# OPERATION AND SERVICE MANUAL

## 8447D 8447E 8447F AMPLIFIER 0.1—1300 MHz

**71. MANUAL BACKDATING CHANGES**

**75. MANUAL CHANGE INSTRUCTIONS****CHANGE A**

Figure 11. 8447D/E/F Cabinet Parts

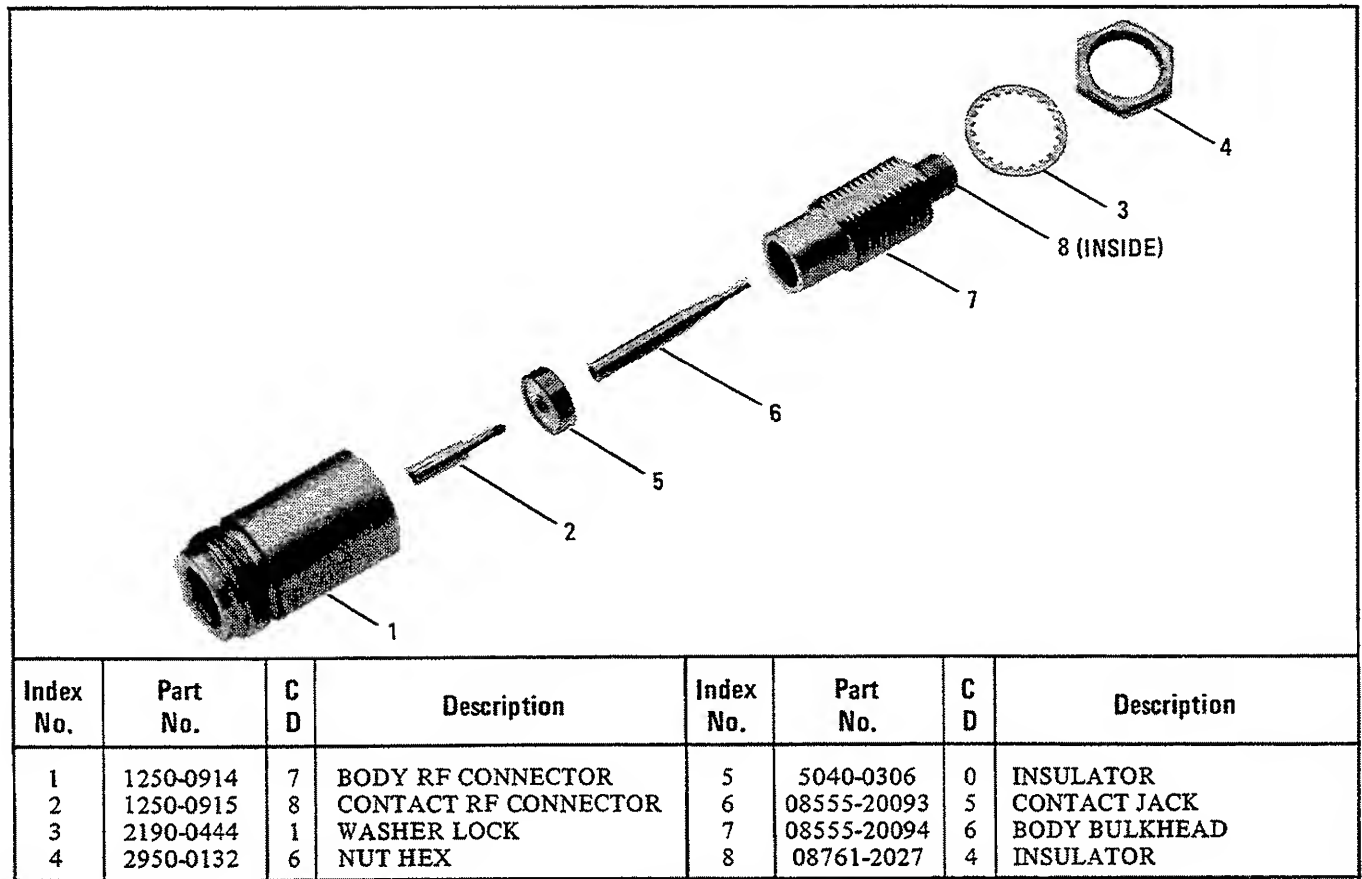
Page 24, Figure 11:

Change Index Number 6 to HP Part Number 08447-00002, Check Digit 3, PANEL REAR, Qty 1.

Page 24, Figure 11:

Delete HP part numbers 08447-00017, 08447-00018, 08447-00019, 08447-00021, 08447-00022, 08447-00023, 08447-00024, 08447-00025, 08447-00040, 08447-00041, 08447-00042, 08447-00043, 08447-00044, 08447-00045, 08447-00046, and 08447-00047 from Index Number 10.

### Page 24, Figure 11:

Delete HP part numbers 08447-00058, 08447-00059, 08447-00060, 08447-00061, 08447-00064, and 08447-00065 from Index Number 10.

Page 24, Figure 11:

Delete HP part numbers 08447-00058, 08447-00059, 08447-00060, and 08447-00061 from Index Number 10.

Page 24, Figure 11:

Delete HP part numbers 08447-00064 and 08447-00065 from Index Number 10.

Figure 14. A1 Power Supply Component Locations

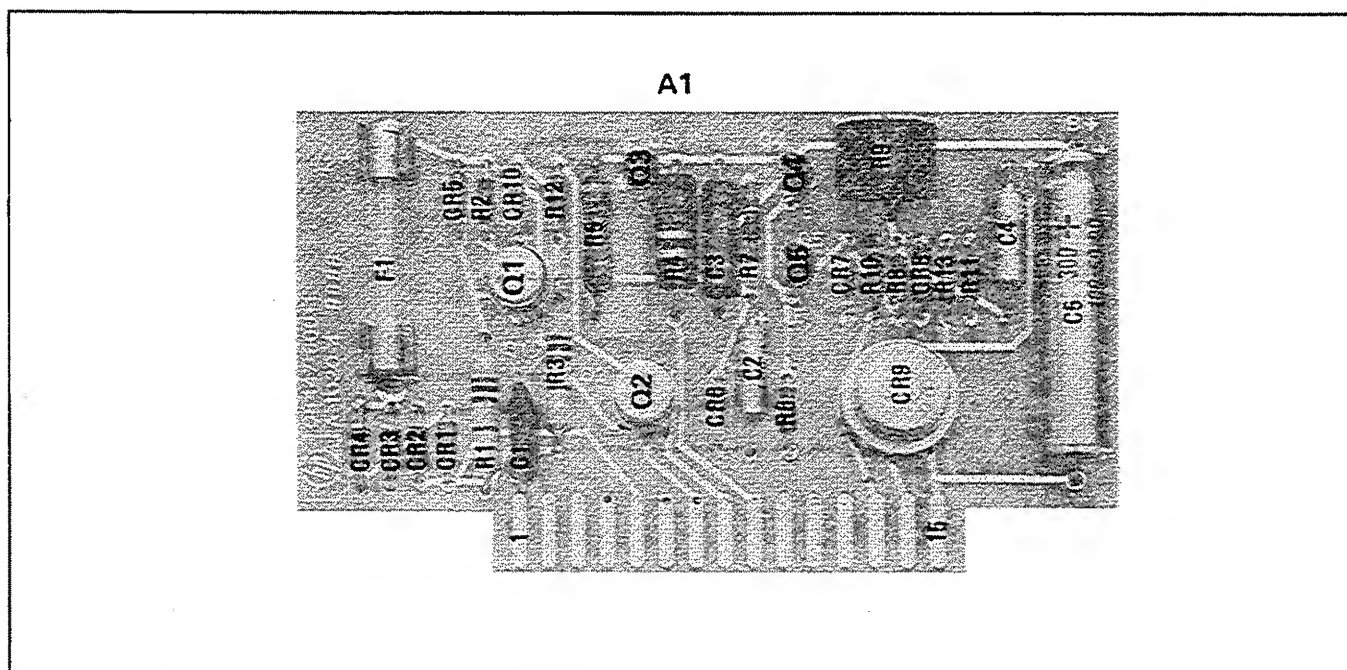
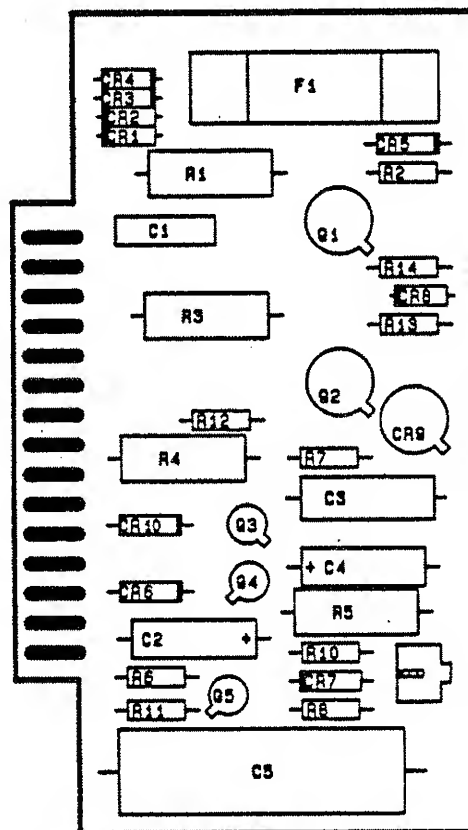
Page 27, Figure 14:

Replace Figure 14 with the new Figure 14, A1 Power Supply Component Locations (ERRATA), included in this Manual Changes supplement.

Figure 15. Amplifier and Power Supply Circuits

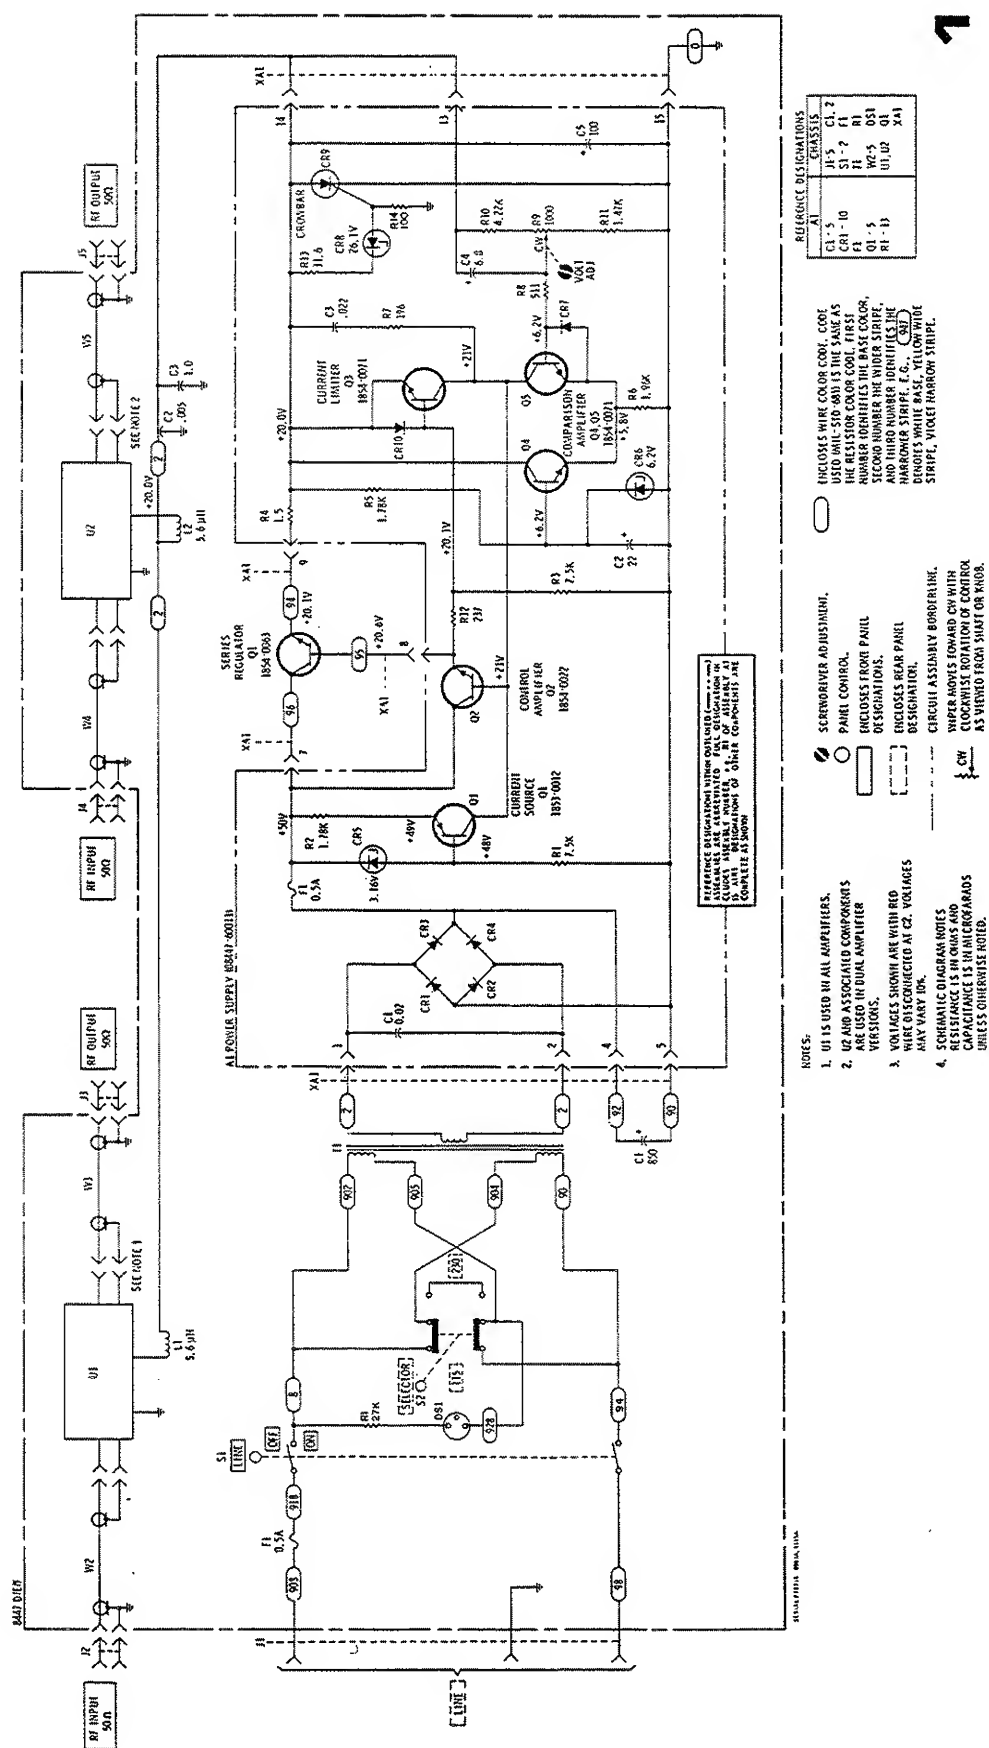
Page 28, Figure 15:

At S1 LINE switch, delete switch connection between wire numbers 98 and 94. Change wire number 94 to wire number 90 and draw a jumper between wire numbers 98 and 90.

Page 28, Figure 15:

Delete resistor R14 and its connection to ground.
